SYMBOL LEGEND REVISION ITEM BALLOON FOCAL POINT FOCAL POINT DESIGNATOR INSPECTION BALLOON WATER TRACE IDENTIFICATION CENTER OF GRAVITY IDENTIFICATION	DETAIL LEVEL: N/A UNLESS OTHERWISE SPECIFIED MACHINE FINISHES SHALL BE: N/A	CLEANING PROCEDURE: MSW-DCP-101, LEVEL II UNLESS OTHERWISE SPECIFIED ALL OTHER SURFACE FINISHES SHALL BE: BRUSH	NO. ZONE ECN # REVISION DESCRIPTION DATE BY CHK
	P.O. Box 10 1925 Route 51 Clairton, PA 15025-3881 phone: 1-800-245-1656 web: www.lesker.com		15/16 Burgess Road Hastings, East Sussex, TN35 4NR United Kingdom phone: +44 01424 458100
	© Kurt J. Lesker Company "...vacuum science is our business"		NOTE: THIS DRAWING, AND ITS CONTENT, IS THE CONFIDENTIAL AND PROPRIETARY INFORMATION OF KURT J. LESKER COMPANY AND CAN NOT BE DISCLOSED OR USED EXCEPT WITH THE EXPRESS WRITTEN PERMISSION OF KURT J. LESKER COMPANY.
	SCALE: FOR REFERENCE ONLY 3/8 APPROVED BY: DATE: _____ CHECKED BY: DATE: _____ DRAWN BY: SHP DATE: 10/30/2012		TITLE: CHAMBER, BOX, 30"x20"x16" ID, 304 SS WITH DIFF PUMPED ORING

Q.C. BY USING 1:1 DRAWING: No DRAUGHTING: No DRAUGHTING BASED ON: -		MATERIAL SPECIFICATION: D 304L STAINLESS STEEL	DRAWING NO.: PRD093559-0100
KJLC PART NUMBER: BX3020C0013

ACKNOWLEDGEMENT REQUEST

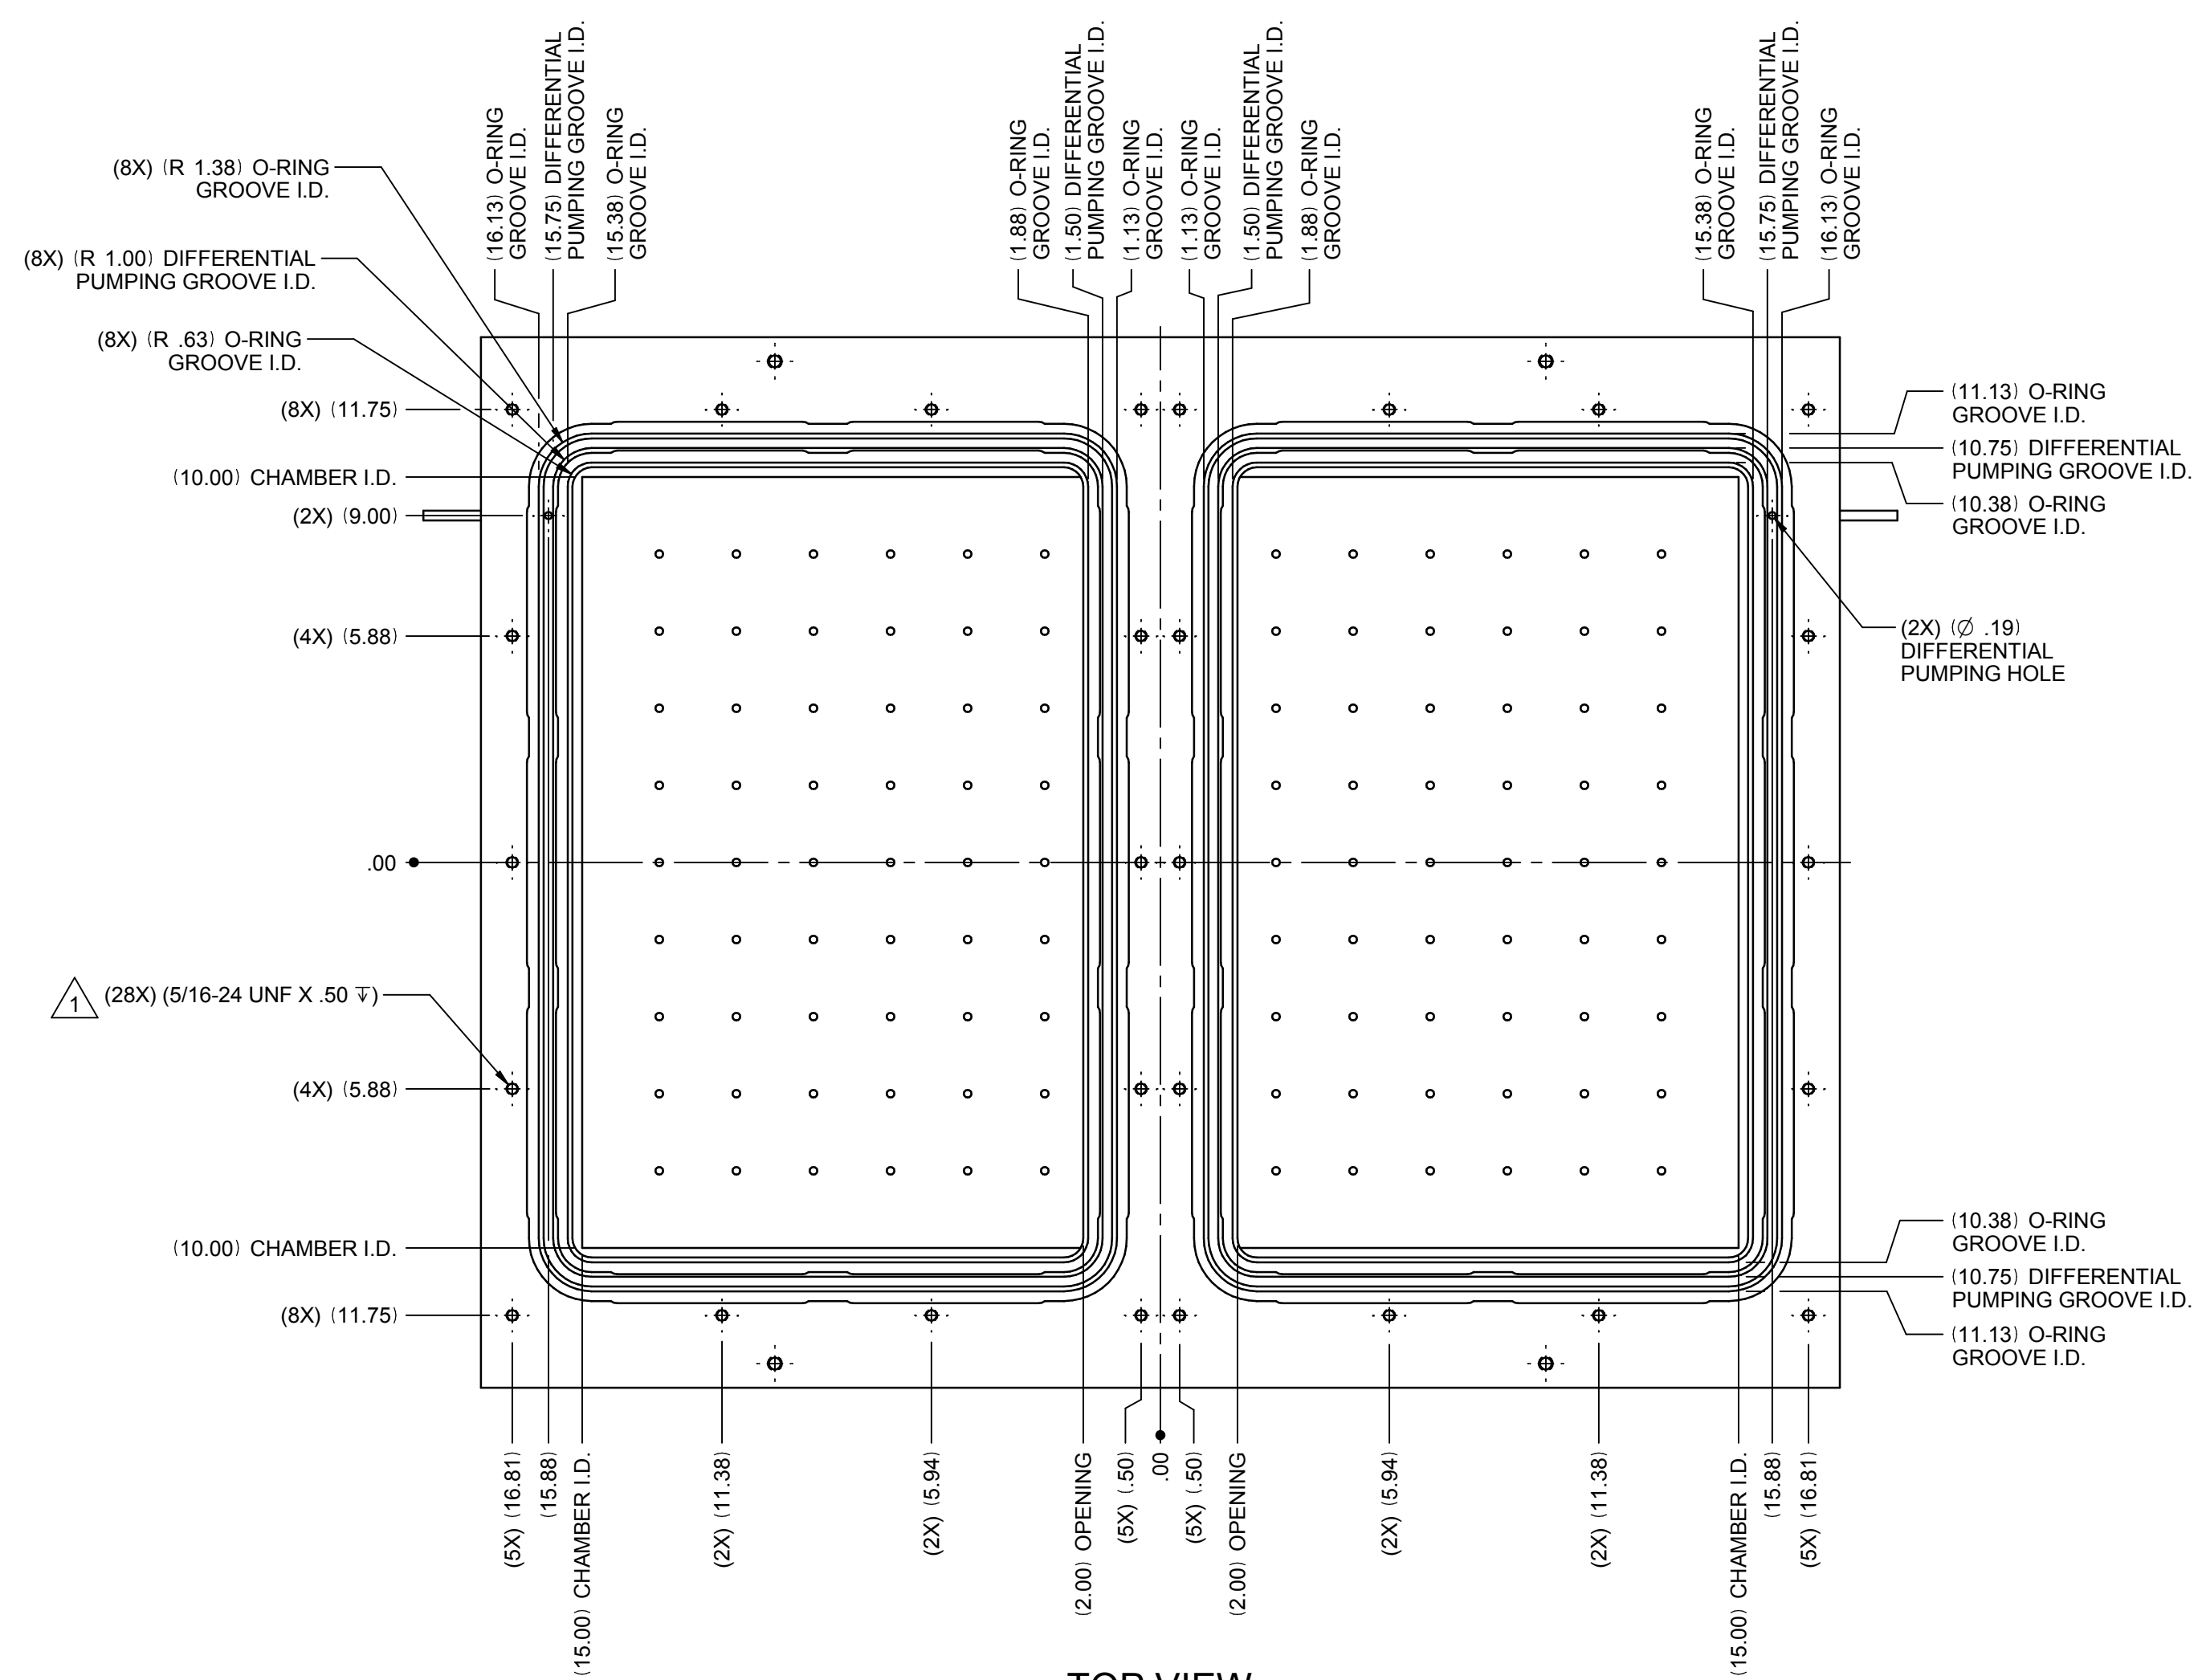
1	ALL	-----	ADDED PORT LABELS; MOVED "A", "B" & "C" PORTS UP 5"; SHORTENED MOUNTING BOSSES BY .5"; ADDED 2" X 2" HOLE PATTERN TO BOTTOM PLATE; LID MOUNTING HARDWARE WAS UNPLATED 1/4-20; ADDED LID HANDLES	11/12/2012	SHP	ENR
0	ALL	-----	RELEASED FOR CUSTOMER APPROVAL	10/31/2012	SHP	ENR
NO.	ZONE	ECN #	REVISION DESCRIPTION	DATE	BY	CHK
<p>P.O. Box 10 1925 Route 51 Clairton, PA 15025-3881 phone: 1-800-245-1656 web: www.lesker.com</p> <p>Kurt J. Lesker Company "...vacuum science is our business"</p> <p>15/16 Burgess Road Hastings, East Sussex, TN35 4NR United Kingdom phone: +44 01424 458100</p>						
NOTE: THIS DRAWING, AND ITS CONTENT, IS THE CONFIDENTIAL AND PROPRIETARY INFORMATION OF KURT J. LESKER COMPANY AND CAN NOT BE DISCLOSED OR USED EXCEPT WITH THE EXPRESS WRITTEN PERMISSION OF KURT J. LESKER COMPANY.						
SCALE: FOR REFERENCE ONLY 3/8			APPROVED BY:	CHECKED BY:	DRAWN BY:	SHP
			DATE:	DATE:	DATE:	10/30/2012
